National Emission Standards for
Hazardous Air Pollutants (NESHAPs) for
Radionuclides

National Emission Standards for Radon
from Operating Mill Tailings

40 CFR Part 61, Subpart W

Background Information for Final Rule
Summary of Public Comments and Responses

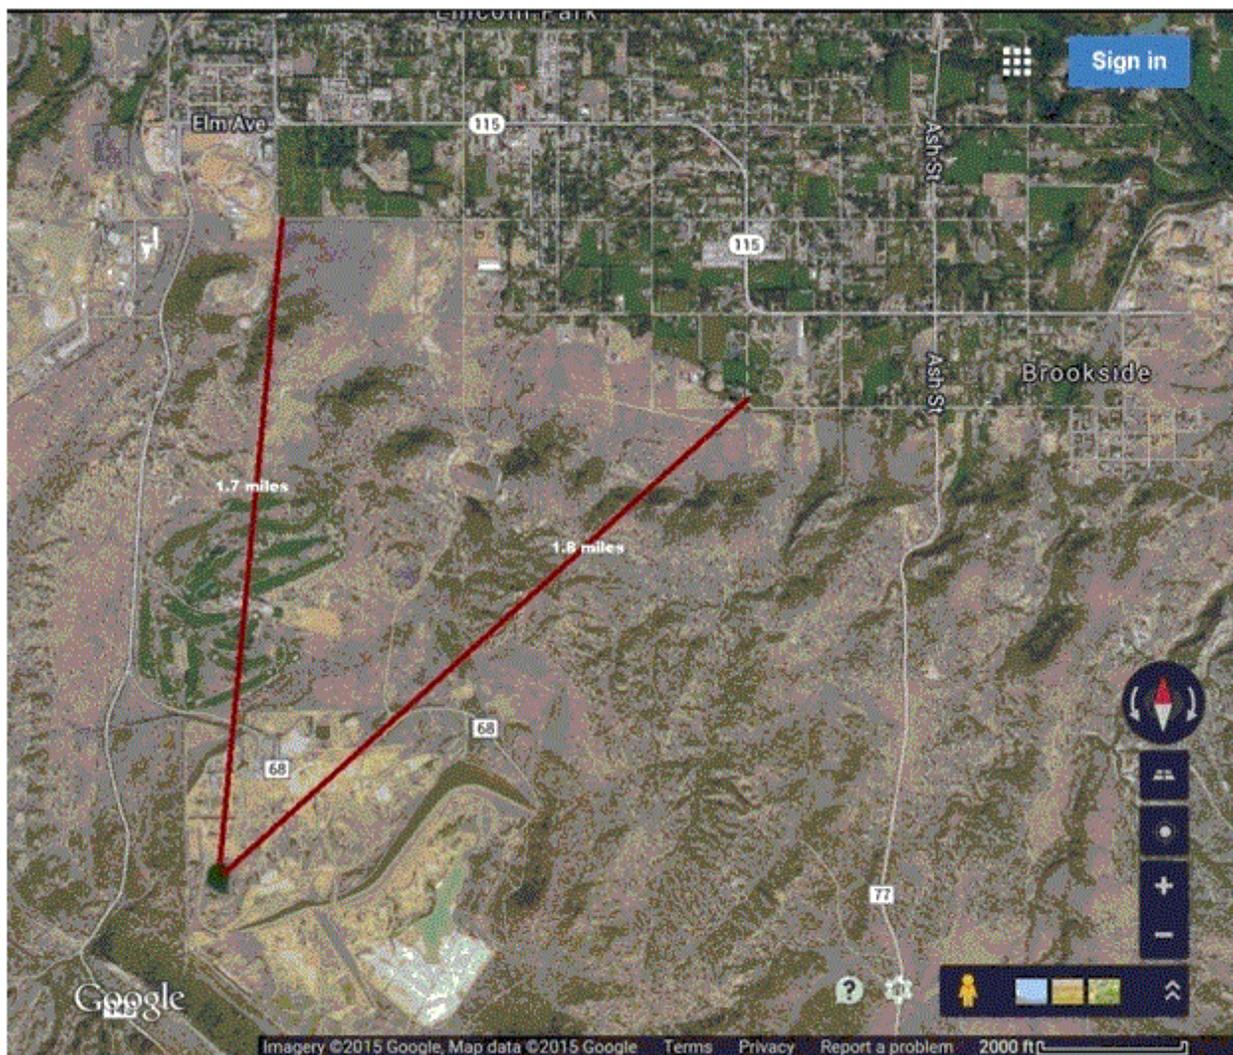
ATSDR’s 2010 Draft PHA identified the distance from the “restricted area” to the nearest home. For the risk assessment it was necessary to use the distance from the release point (the impoundment that is the source of radon) to the nearest home.

Table 15 in the risk assessment shows that within the 2-mile (3.2 km) and 5-mile (8.0 km) radii, about 1,000 and 22,000 people were estimated, respectively (the commenter stated that there are 6,000 residents to the north and west alone within 2 miles of the facility, and 20,000 within 5 miles). We followed the commenter’s suggestion, went to Google Maps, and looked for streets of residents north of the mill. As the image below shows, within 1.7 to 1.8 miles north of the mill’s impoundment, there are no identifiable streets of residents. West and west-north-west of the mill (e.g., Eagle Drive, Shiloh Drive) the map shows new developments. Individuals in these areas were evaluated in the risk assessment (page 21), which found that an individual living 1 to 2 kilometers north of the site was the RMEI (reasonably maximally exposed individual), as opposed to individuals located to the west or west-north-west of the site. Also, at 22,000, the total population estimated within a 5-mile radius is slightly greater than the 20,000 people that the commenter suggests should be used.

The reason for the greater discrepancy in the estimated population within 2 miles is unclear. Using the commenter’s population values, a population density in the 0 to 2 mile zone of about 480 people per square mile was calculated, and in the 2 to 5 mile zone, a density of about 210 people per square mile. As can be seen in the Google image below, there does not appear to be twice the population density close to the site as there is farther from the site.

Regarding the radon release estimates, Table 18 of the risk assessment shows measured values for radon flux from the primary and secondary impoundments as reported by the Cotter facility from 1999 to 2009. Radon releases were then calculated from these flux measurements. Commenter 0158 provided documents that purport to show available data that EPA has not considered. The commenter's Attachment 3, Table RF-1 ("Mean Radon Flux – Primary and Secondary Impoundments," page 47) presents the same data contained in Table 18 of the risk assessment. The commenter's information does not contain measurements on total radon releases. The measured fluxes from the impoundment provide the appropriate comparison to the Subpart W emission standard for pre-1989 impoundments, and allow for calculation of releases to serve as the basis for the risk assessment (see Table 19 of the risk assessment for results of the analysis of the Cotter site). Subpart W does not apply to other sources of radon that may be present at the site, such as ore piles.
